PROPOSED S4.55(8) MODIFICATIONS LIST:

9-11 VICTORIA PARADE, MANLY, NSW

DRAWING TITLE			PROJECT
SECOND BASEMENT PLAN			VPM
SCALE	STATUS	NUMBER	REVISION
1 : 100	s4.55 (8)	A1.01 a	A

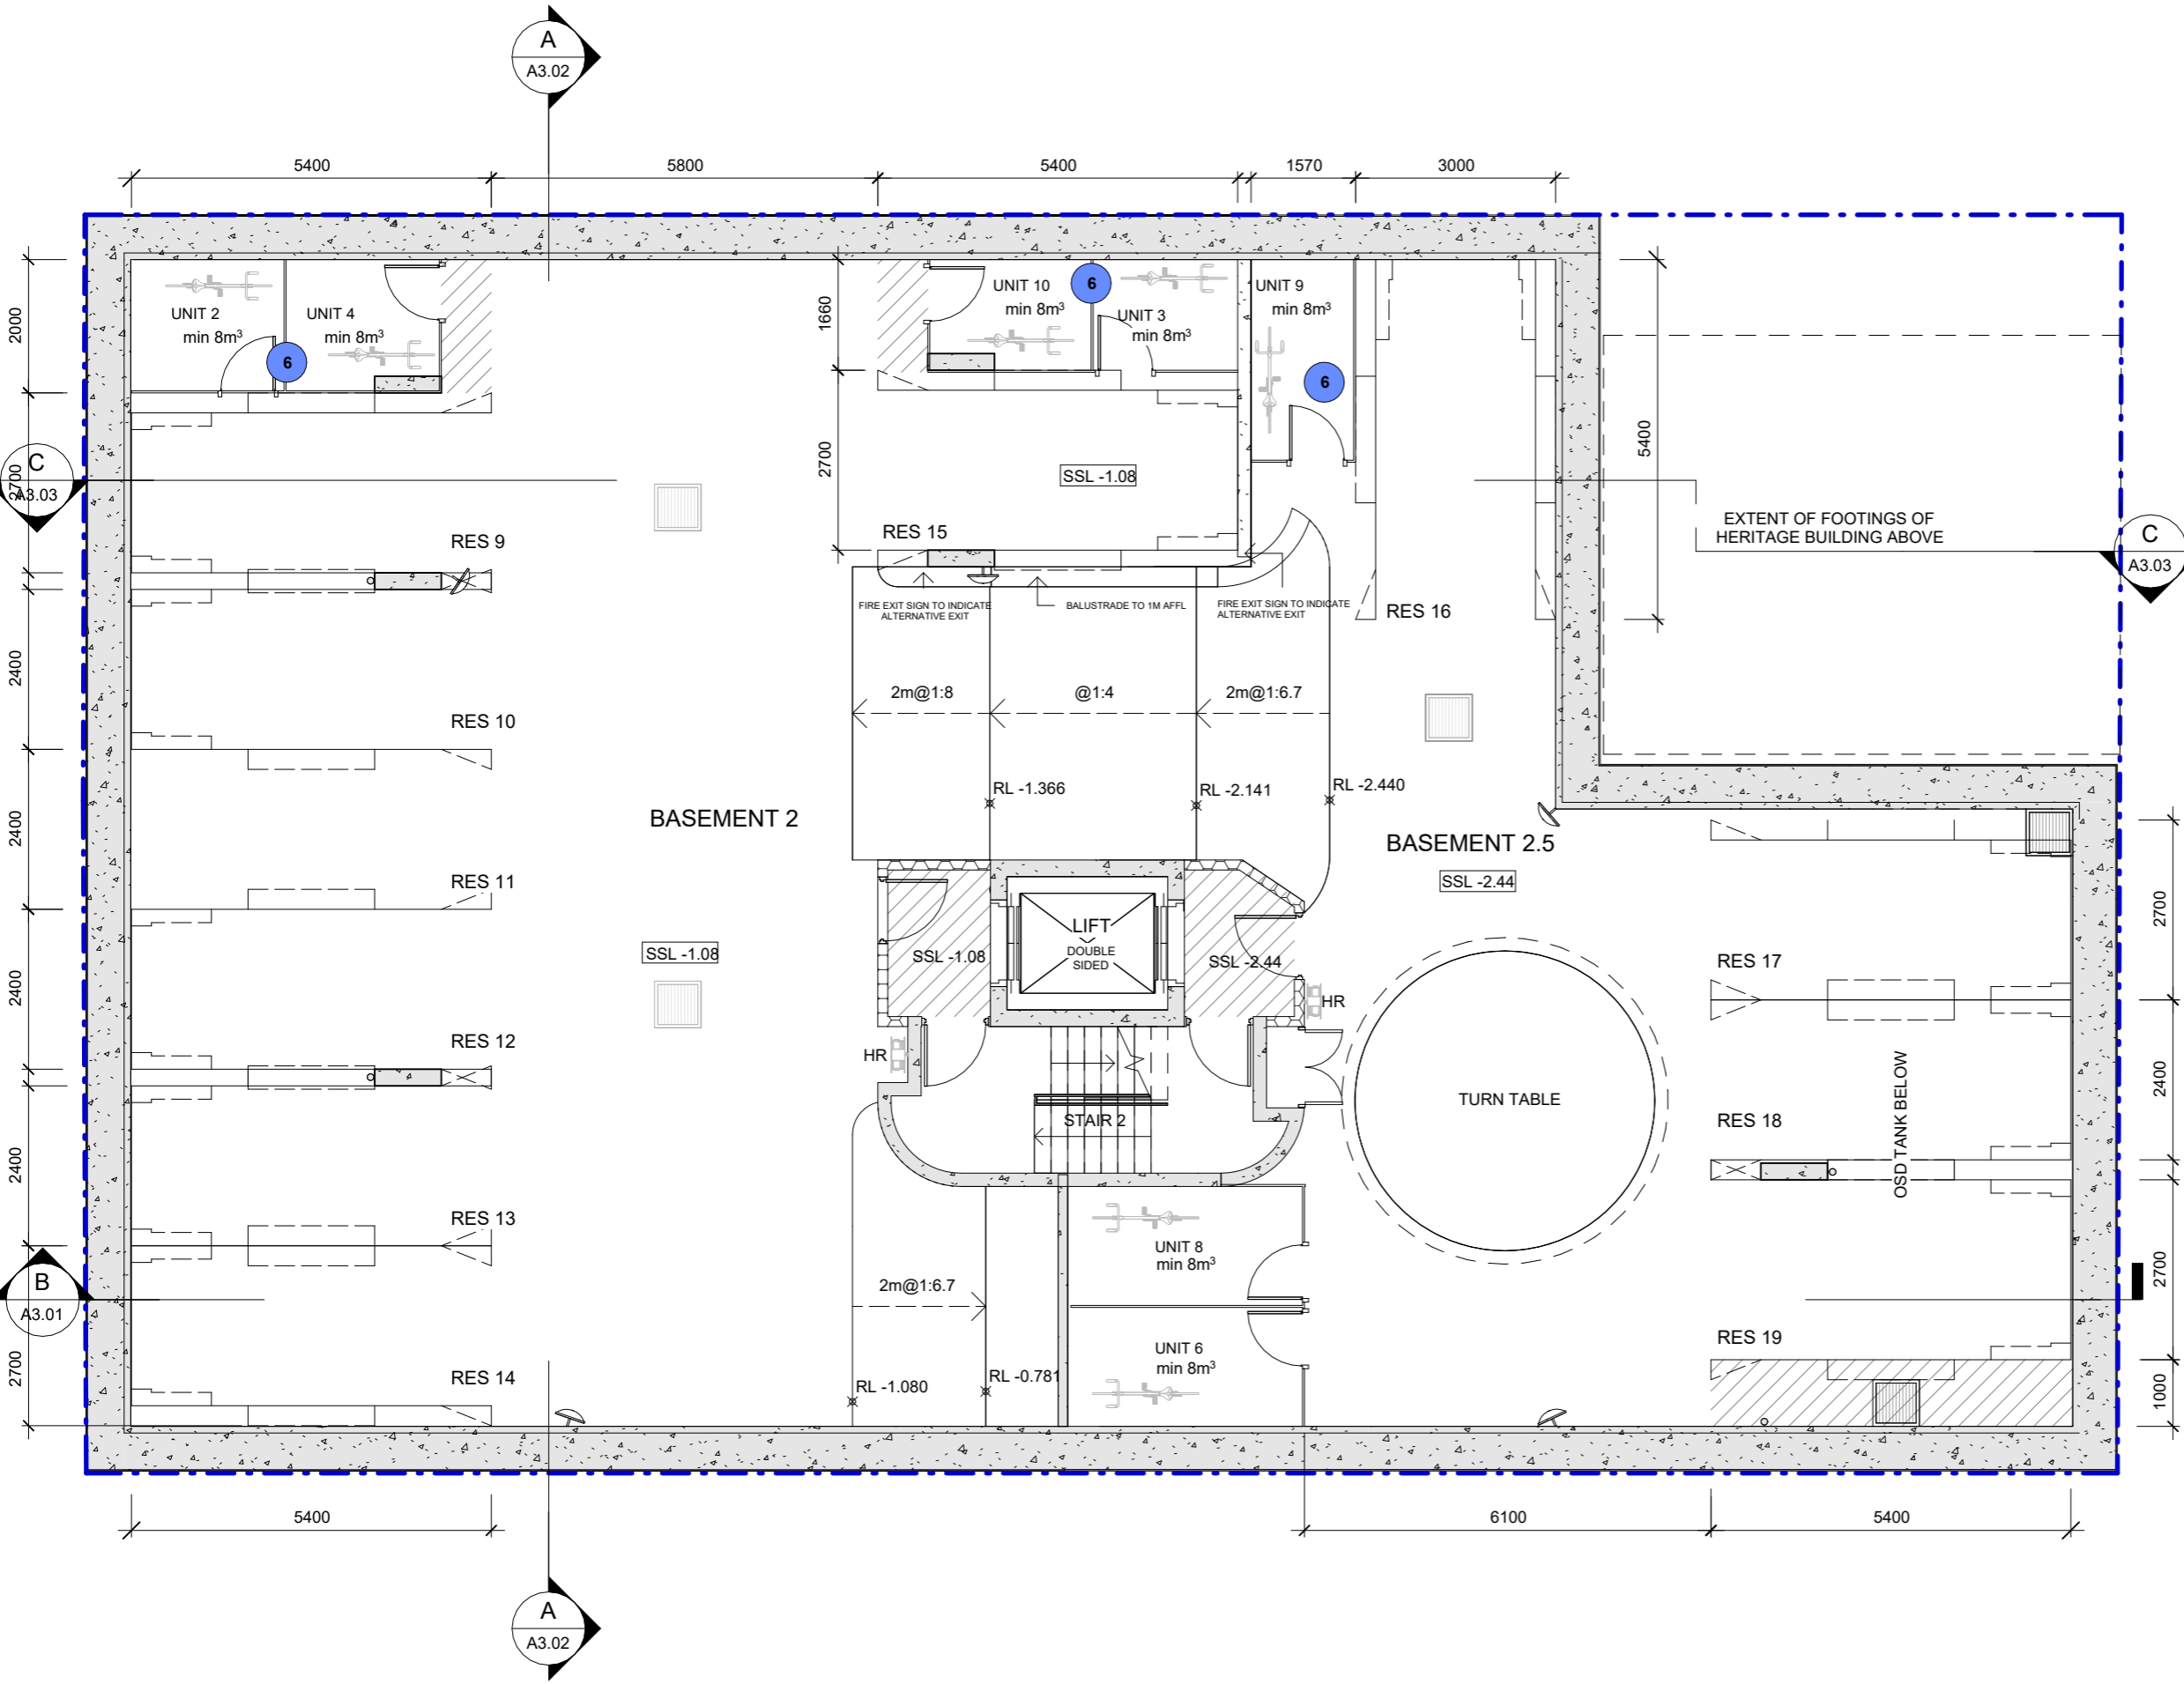
6. Allocation of 1 bicycle space per unit in large storage cages in lieu of separate bicycle parking to satisfy the intention of condition 43D.
7. Private roof terrace introduced to improve amenity of unit 14. The glass stair enclosure is not readily visible from the street and has no real impact on privacy, bulk or overshadowing.
